## 7. COA-045485-2018

2327 Monument Avenue

# Commission of Architectural Review

## STAFF REPORT

Figure 1. 2327 Monument Ave, ca. 1924

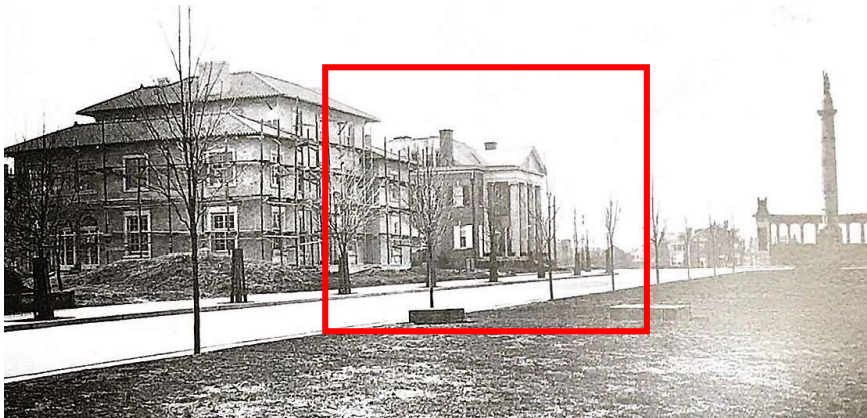
Staff finds that the existing front-yard fence was installed sometime between 2001 and 2007 and was unable to find records of CAR approval of the fence. Photographic documentation indicates that there historically was not a front yard fence at this home (see

Fences #5, pg. 78	<i>In the event of a conjectural fence, the design should seek simplicity, rather than elaboration.</i>	Figure 1). <u>Staff recommends denial of the proposed gate.</u> The proposed ornate design of the gate is not appropriate for the structure or the District and is contrary the Guidelines which call for simplified gate designs and not elaborate conjectural designs.
Standards for Rehabilitation #7, Pg. 59	<i>Repair damaged elements instead of replacing them. Use materials that match the original.</i>	The applicant has stated that the limestone steps need to be replaced. Some of the steps do appear cracked, however others are in good condition and limestone can be repaired. <u>Staff recommends the applicant work with staff to determine if the steps can be repaired and submit additional documentation on their condition. Only the steps that are beyond repair should be replaced in-kind.</u>
